Proposed: Retrospective Application to Retain Increased Depth of Dormer Window and Lower Positions of Roof Lights Facing No 14, South Drive and Croft Gardens As Approved Application No - 13950/APP/2022/2305

Drawings: Pre Existing, Approved and Proposed Floor Plans & Elevations

Drawing No: P/MAC/2023/001/G

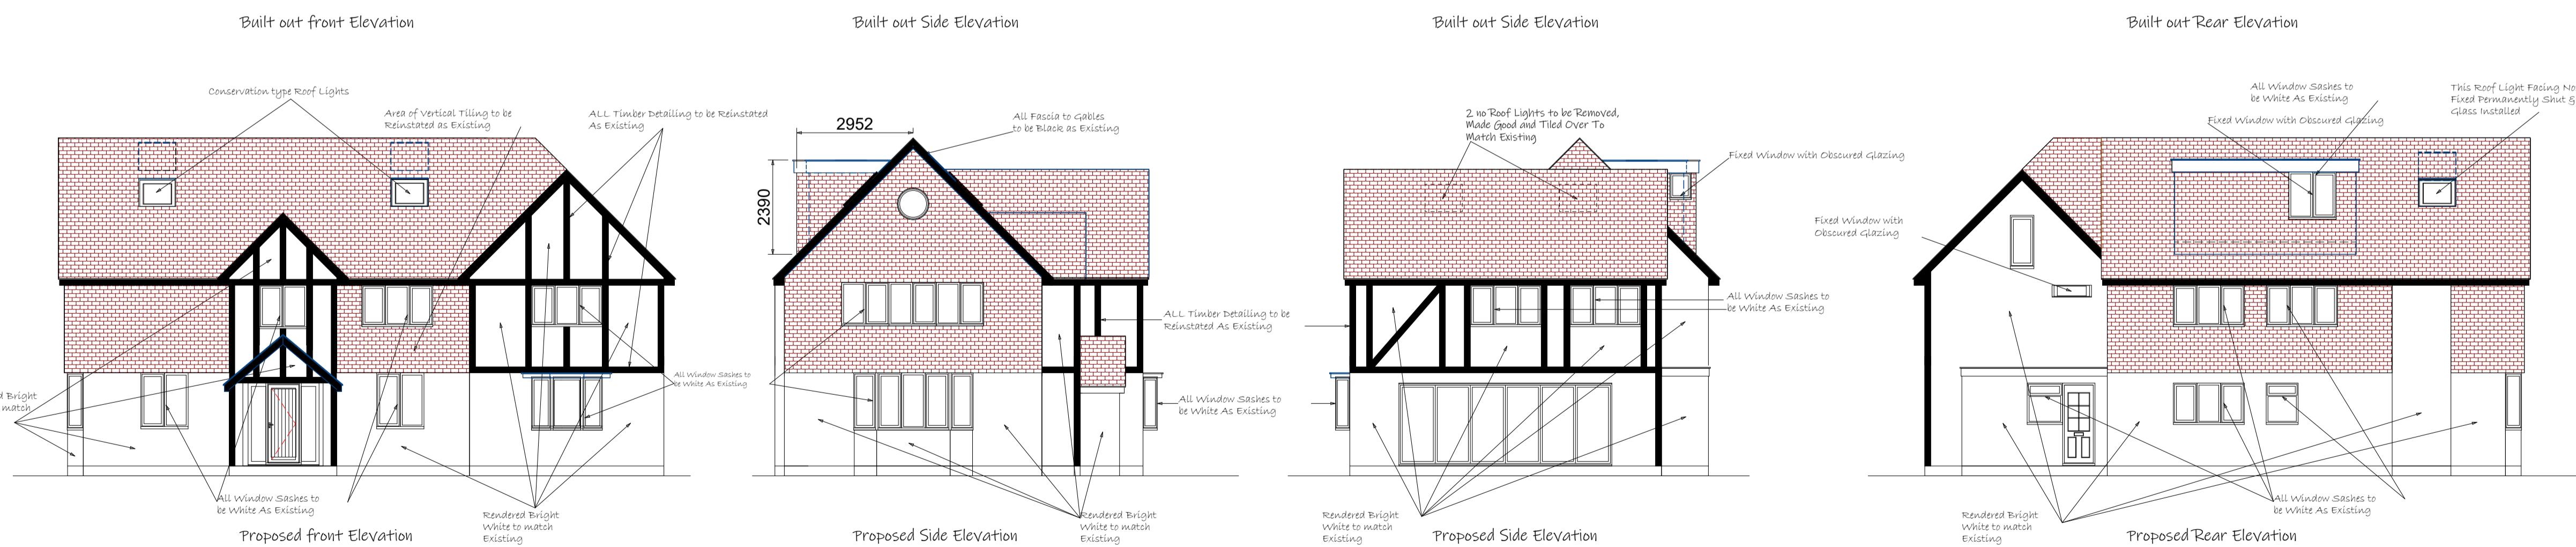
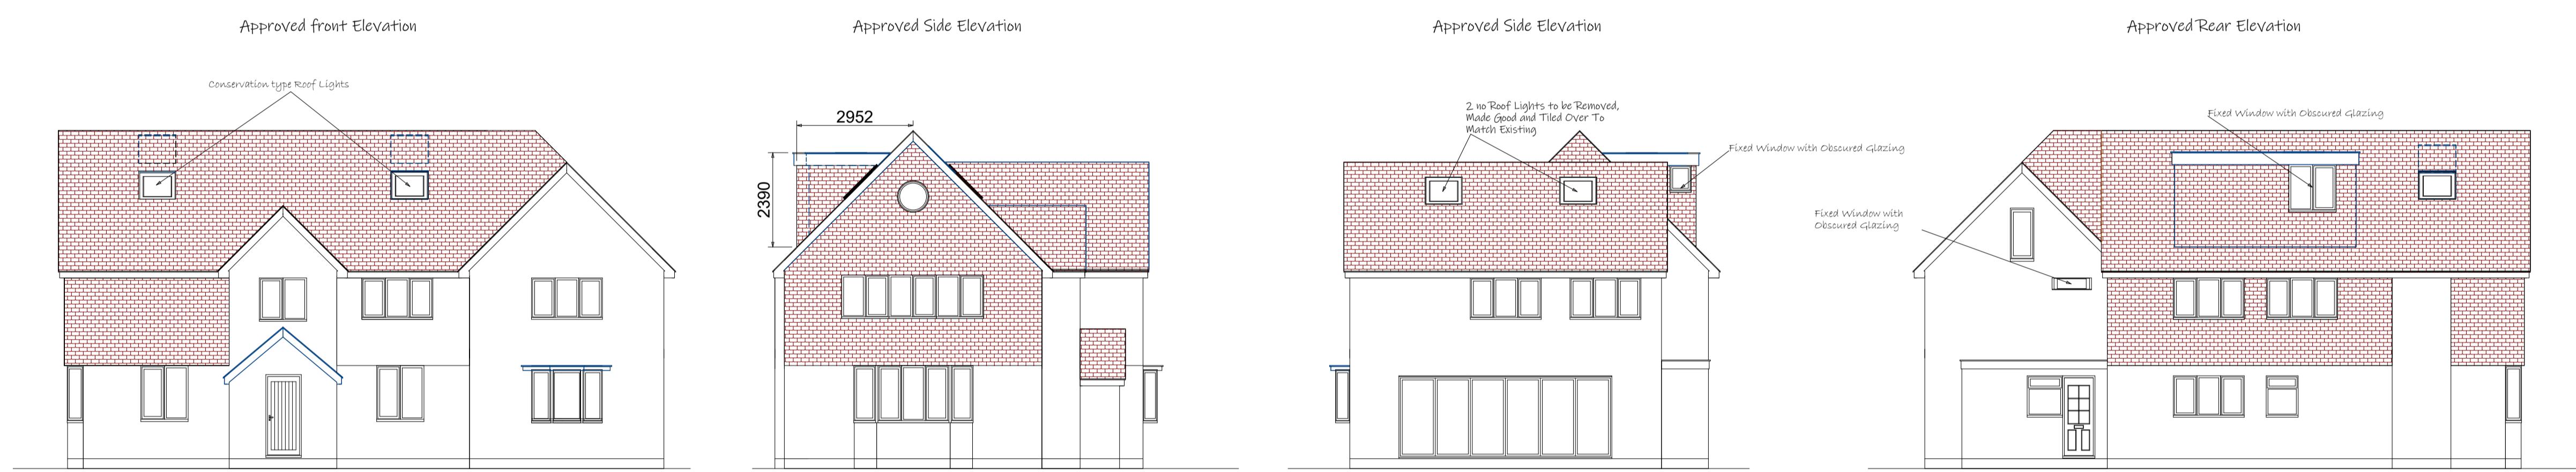
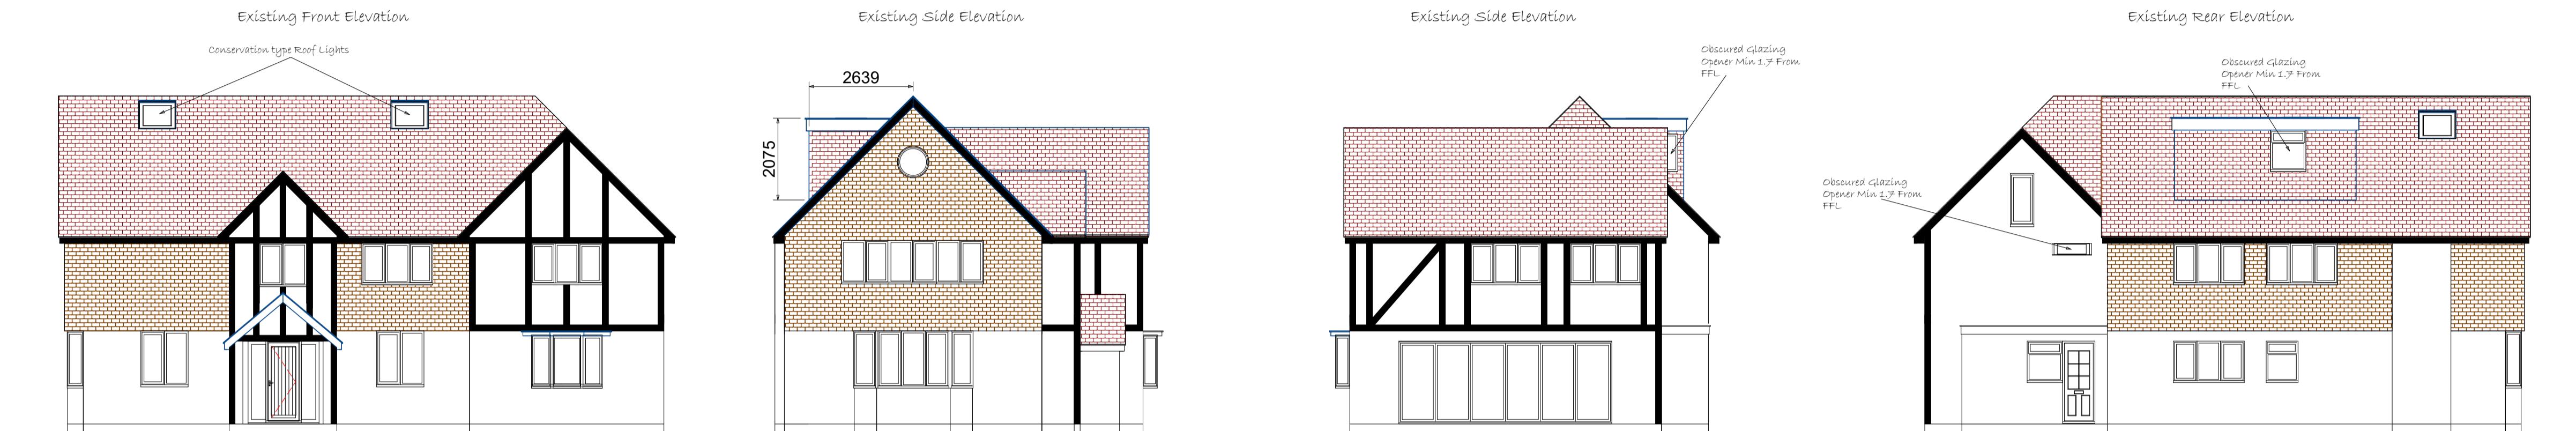
1. ALL timber detailing to be reinstated as Existing.
2. Sashes of replacement windows to be black as existing.
3. Replace ALL hanging tiles as existing.
4. Change of colour of roof tiles due to being replaced with NEW where the existing had decades of weathering.
5. Colour of NEW rendering is closest match which was originally white.
6. ALL fascia Gables to be reinstated in black as existing.

06/10/2023 - Revisions and Confirmations For Planning purposes:
 1. All window sashes to be white as original sashes.
 2. All render to be coated/painted white as original render.
